The Corporation of the  
CITY OF WHITE ROCK

Board of Variance  
AGENDA

Wednesday, August 14, 2024, 3:30 p.m.

**DATE:** August 14, 2024  
**TO:** Board of Variance  
**FROM:** Sophia Bihari, Planning and Development Assistant II  
**SUBJECT:** Board of Variance Application for 15570 Victoria Avenue (BOV 24-016)

Figure 2: North Elevation Drawing

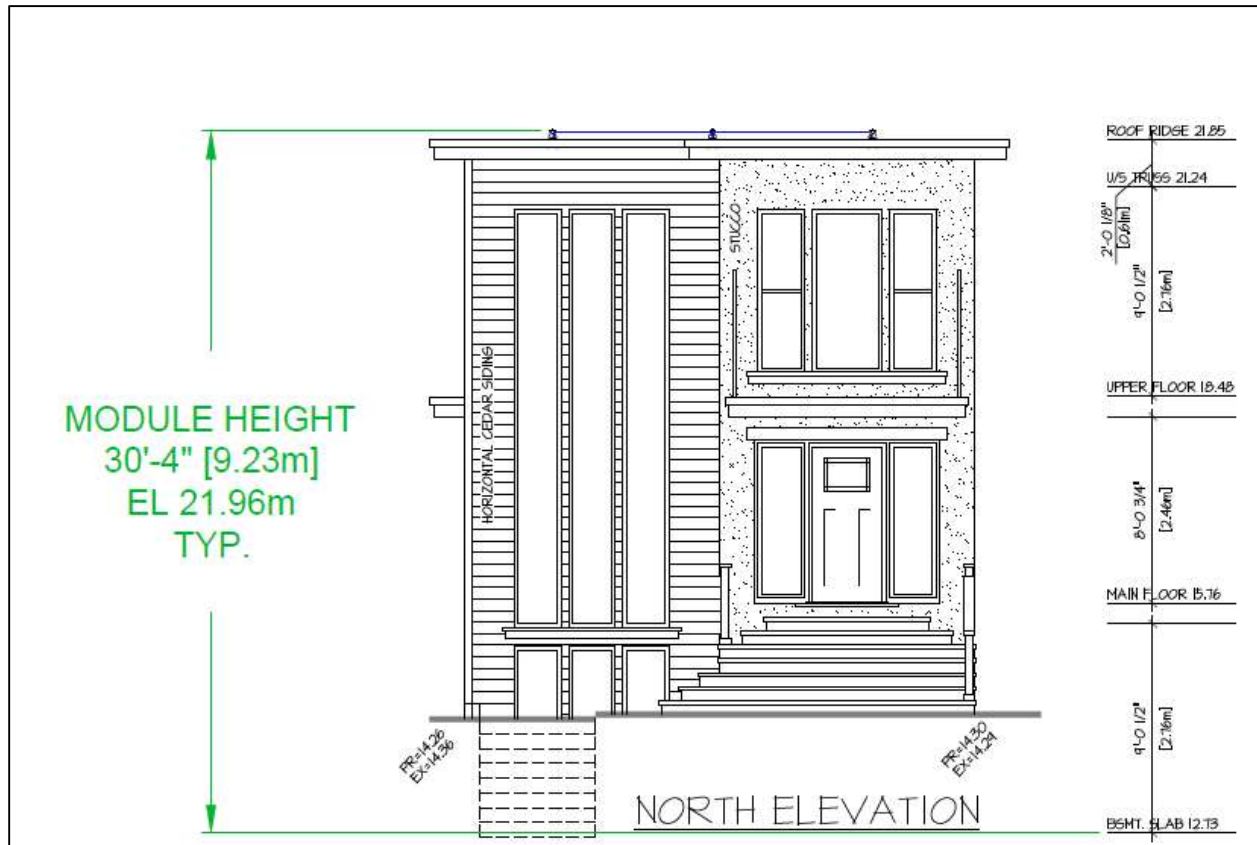
To accommodate the installation of solar panels on the flat roof of the subject property, the applicant is seeking a variance to increase the maximum permitted height of the principal building of the RS-3 (Small Lot, hillside) SSMUH Residential Zone from 7.7m (25.26ft) to 7.91m (25.95ft) per Section 6.3.8 of the Zoning Bylaw. A north elevation drawing which shows the proposed solar panel installation on the roof is provided below (see Figure 2)

Section 6.3.8(1) of the Zoning Bylaw limits a principal building from exceeding a maximum height of 7.7m. In this proposal, the proposed exterior architectural features exceed the maximum permitted height, resulting in a requested relief of 0.21m from the maximum permitted height for a principal building.

Additionally, Section 4.13.5 of the Zoning bylaw notes that heights of buildings and structures in all SSMUH residential zones shall not exceed the maximum height prescribed under the applicable zone.

**FOR PERMITTING**

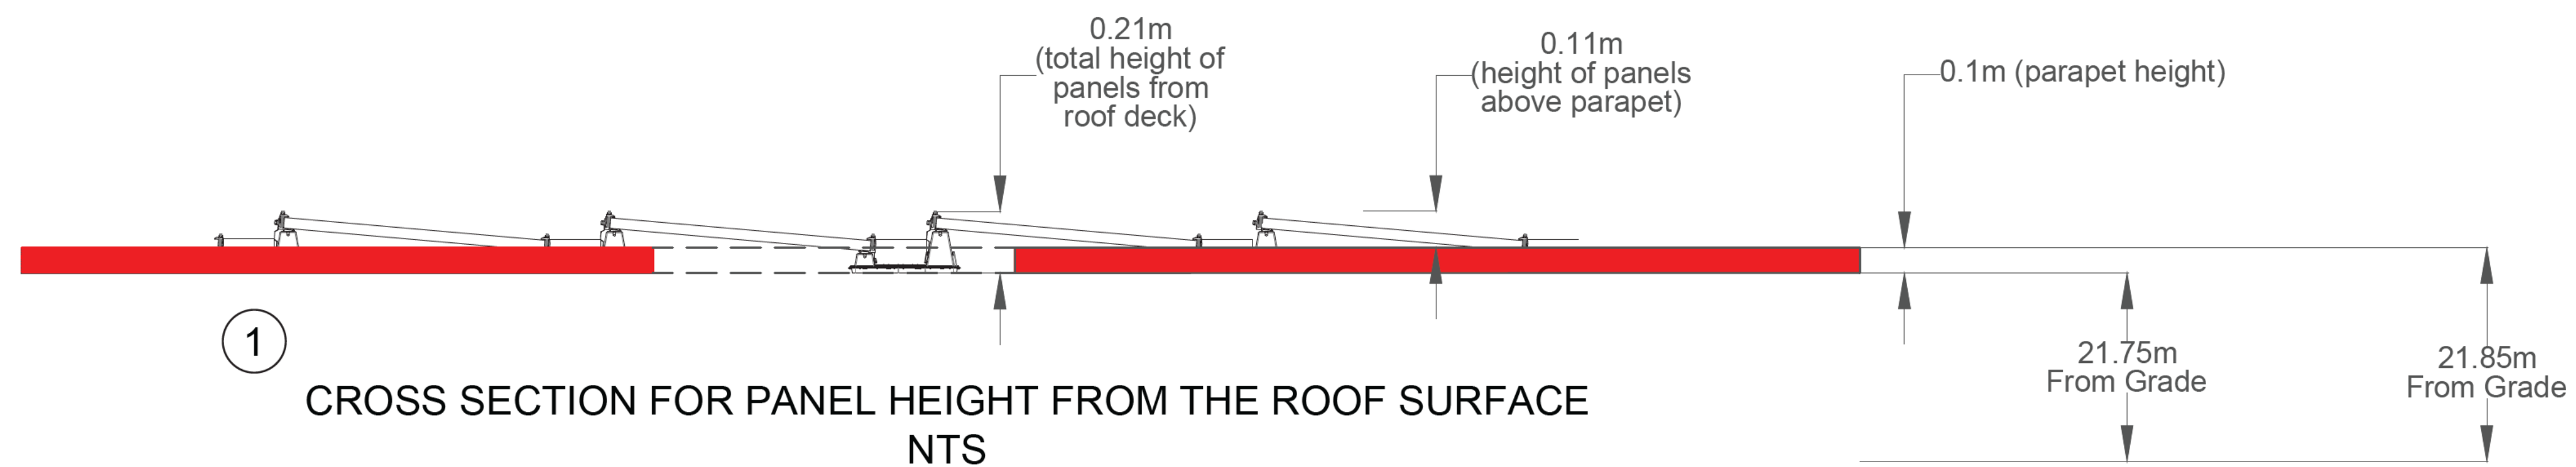
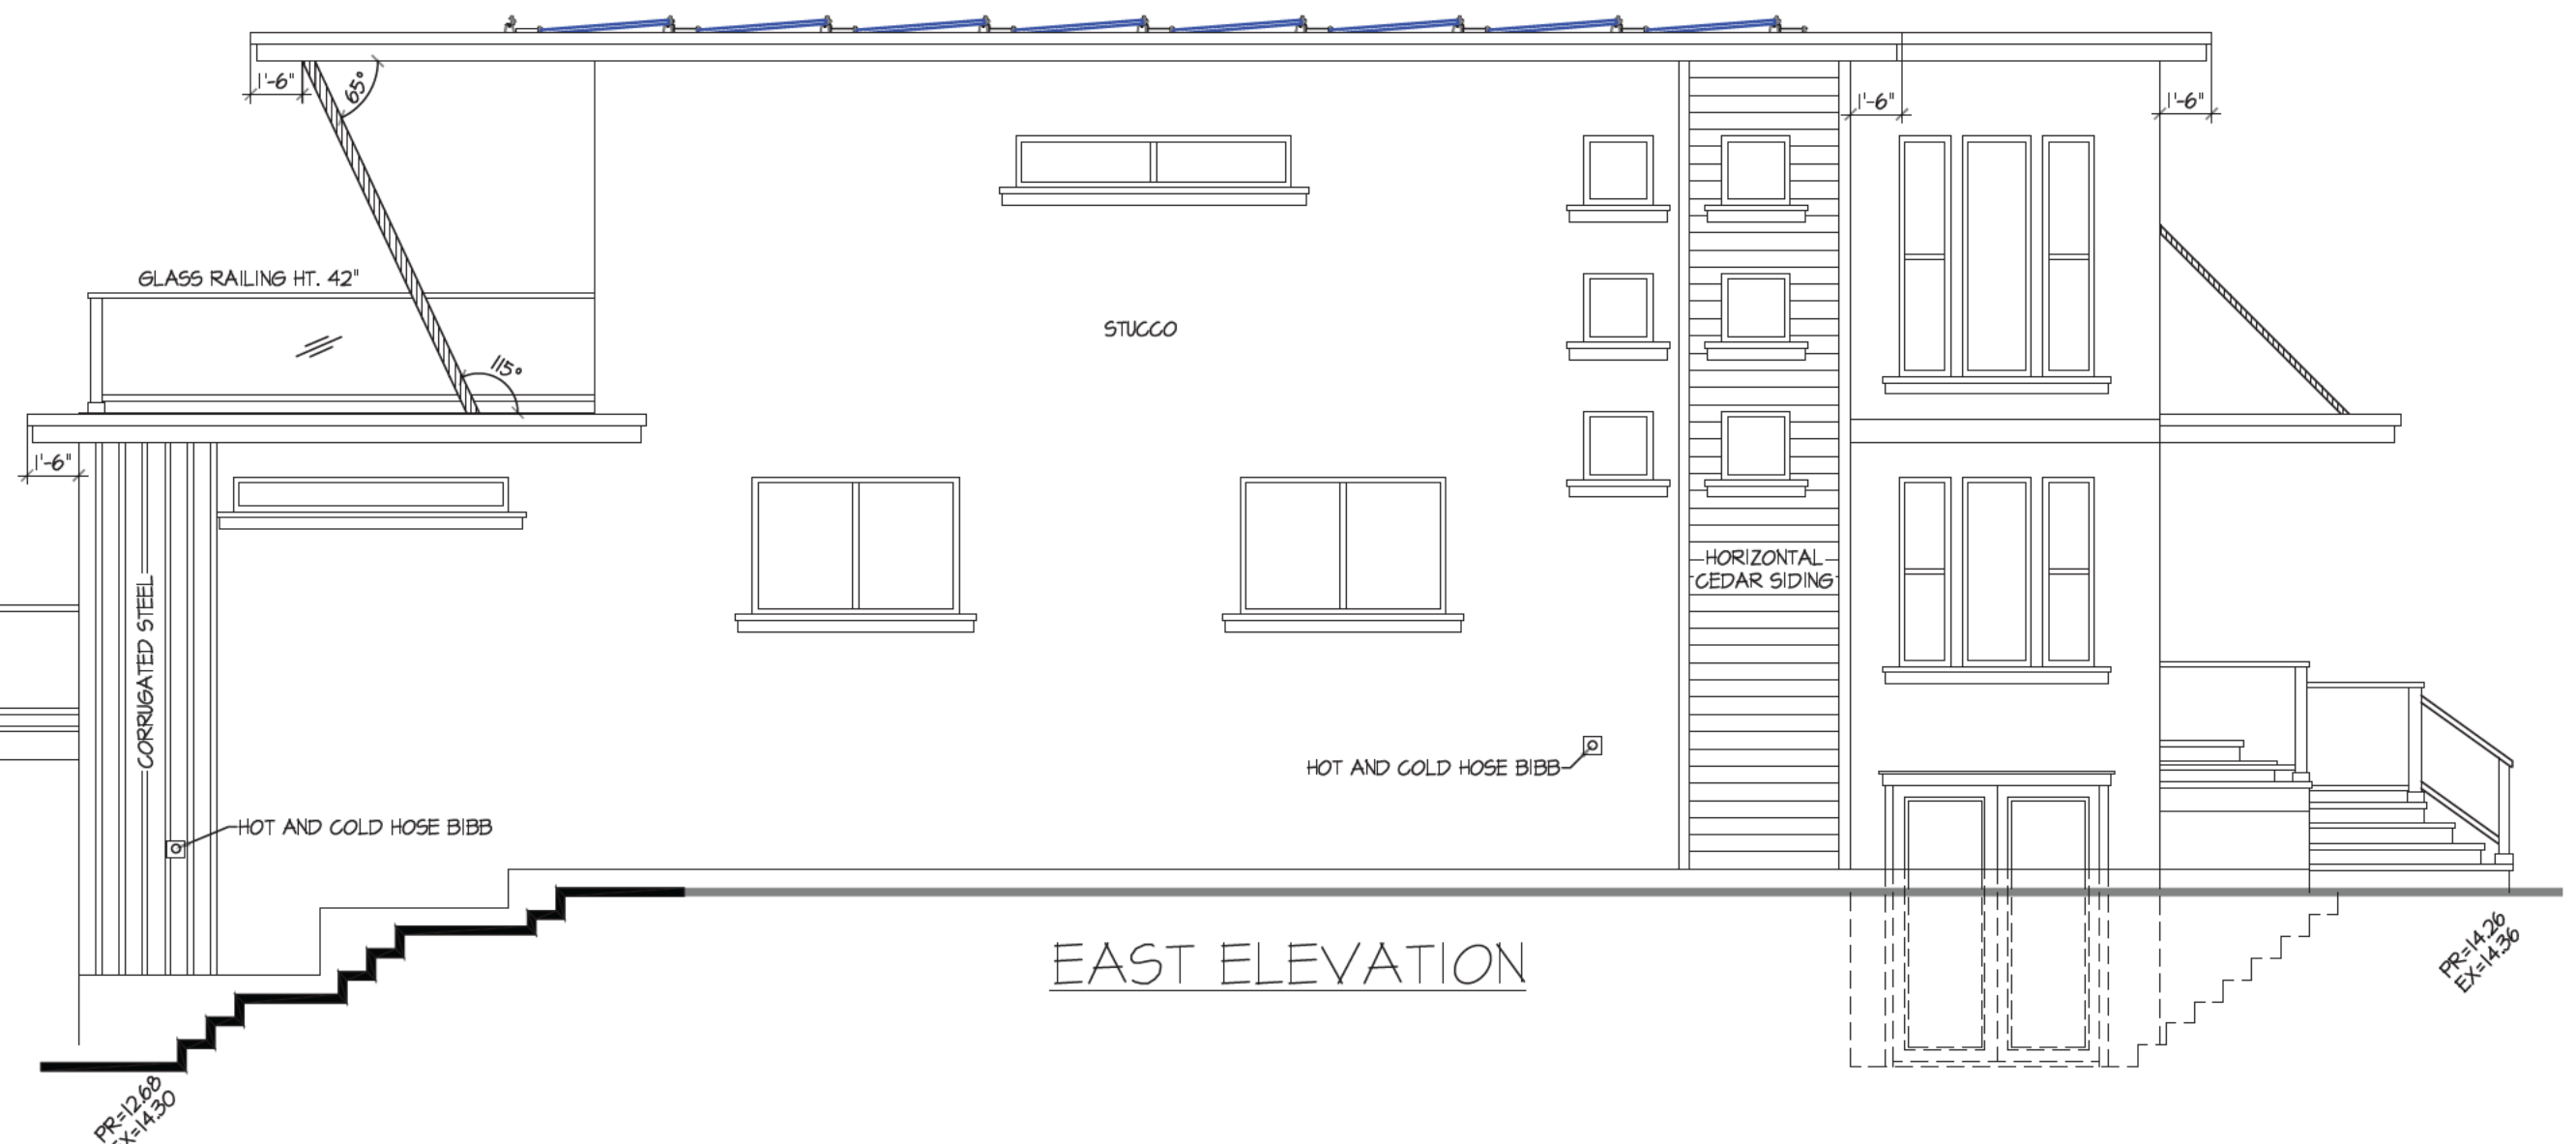
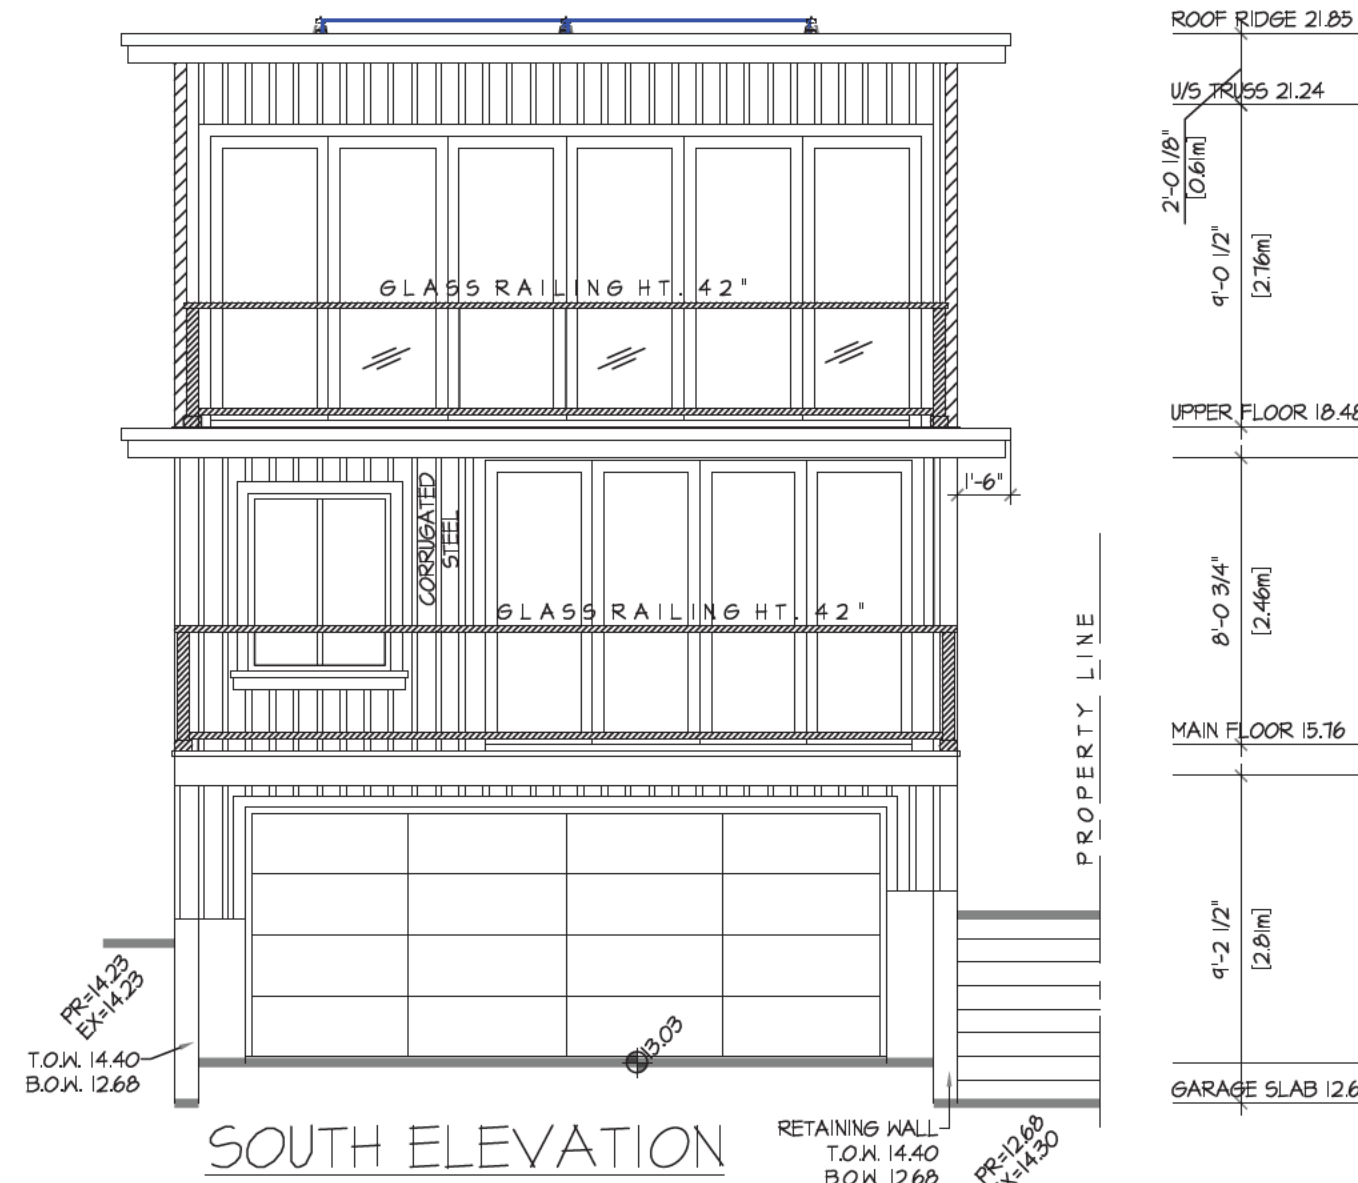
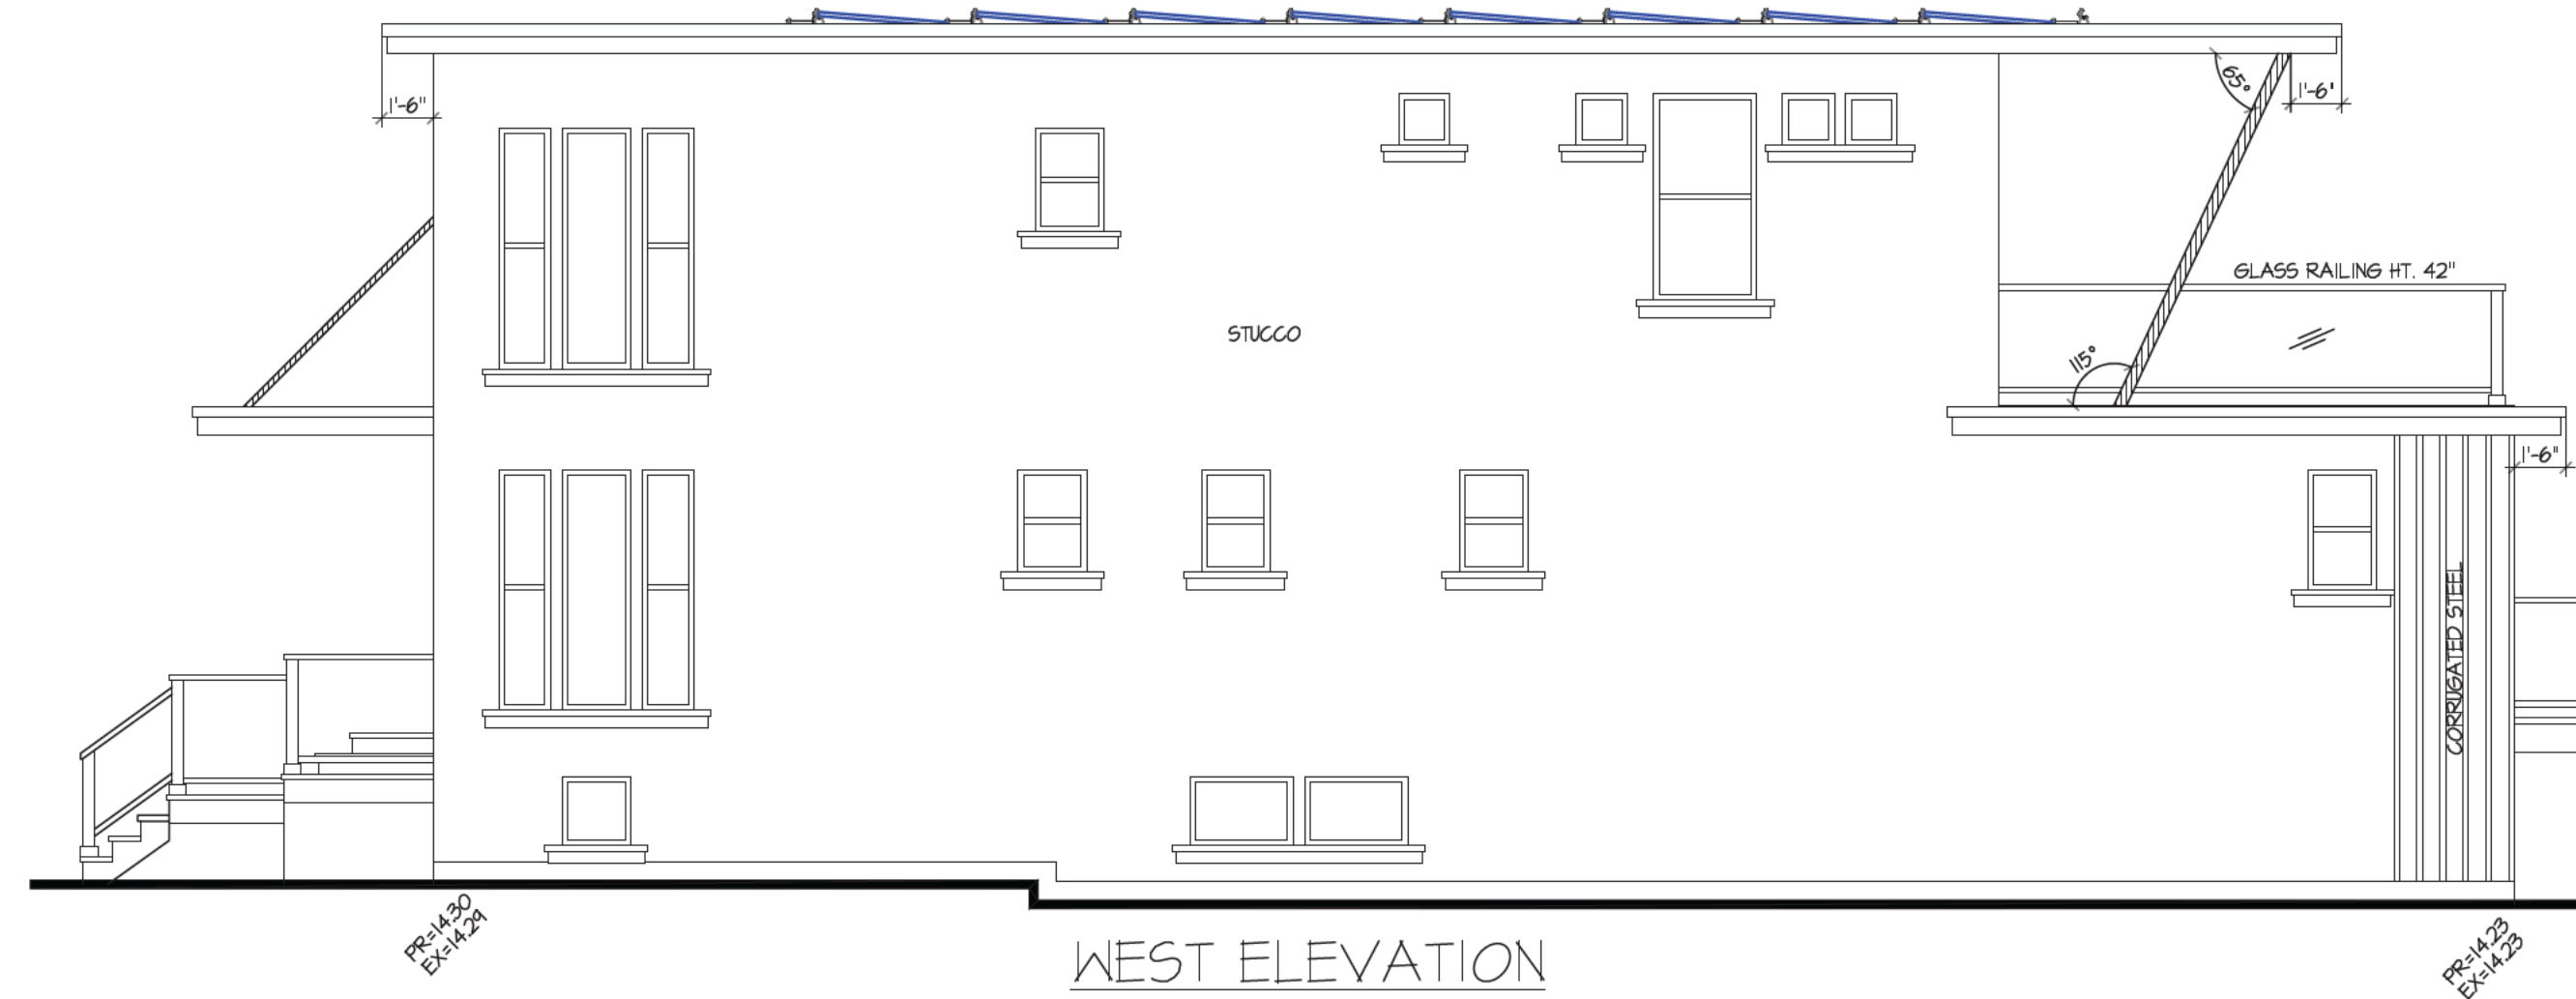
The Building Division noted that loading, wind and seismic information would be required on the structural and design drawings at the building permit application stage.

Figure 1: Southwest corner wall encroachment (red) into the required exterior lot corner clear area

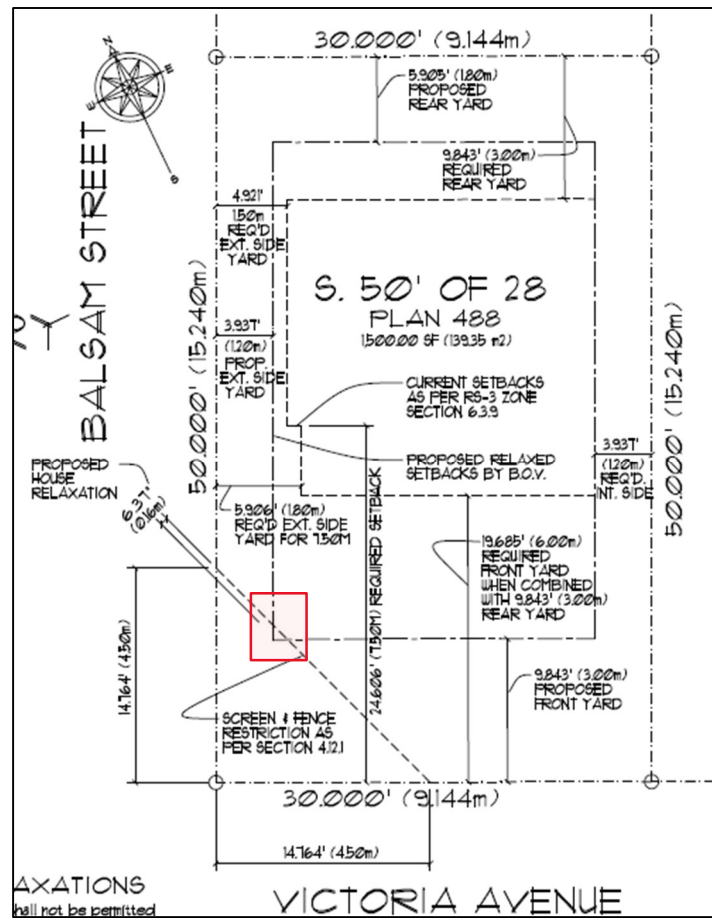
- a) To reduce the minimum exterior lot corner clear area requirement from 4.5 metres to 4.34 metres. This 0.16-metre reduction is to permit the southwest corner wall (over 1.0m in

height) of the proposed principal building to fall within this clear area. (see Figure 1 below).

Figure 2: West Elevation

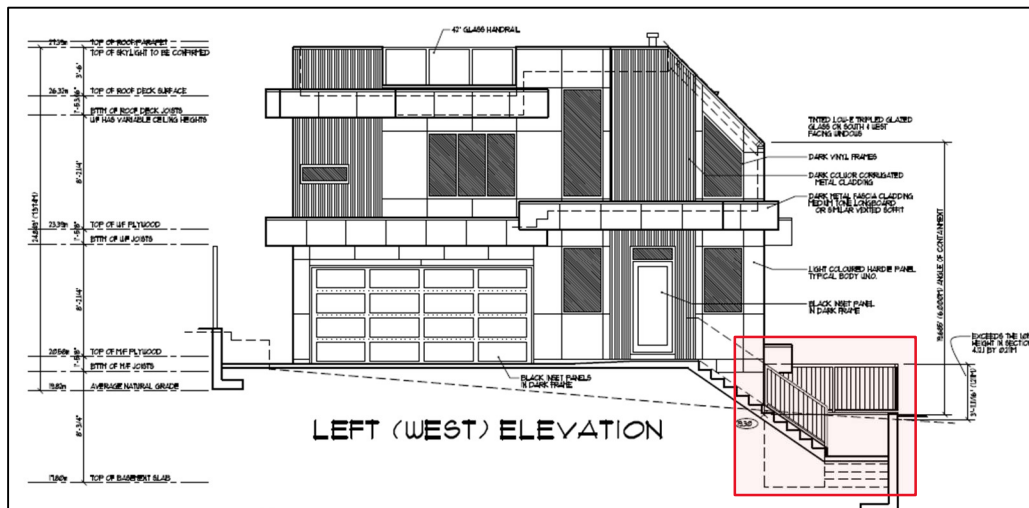
- b) To remove the requirement of the exterior lot corner clear area of 4.5m for structures over 1.0 metres in height to enable the installation of guardrails. (See Figure 2 – West Elevation for requested variance)

The Building Division noted that the visual sight line for vehicles will be disrupted by screening and guards within the exterior corner lot setbacks, per the proposed variance stated in #2, causing a significant safety concern.
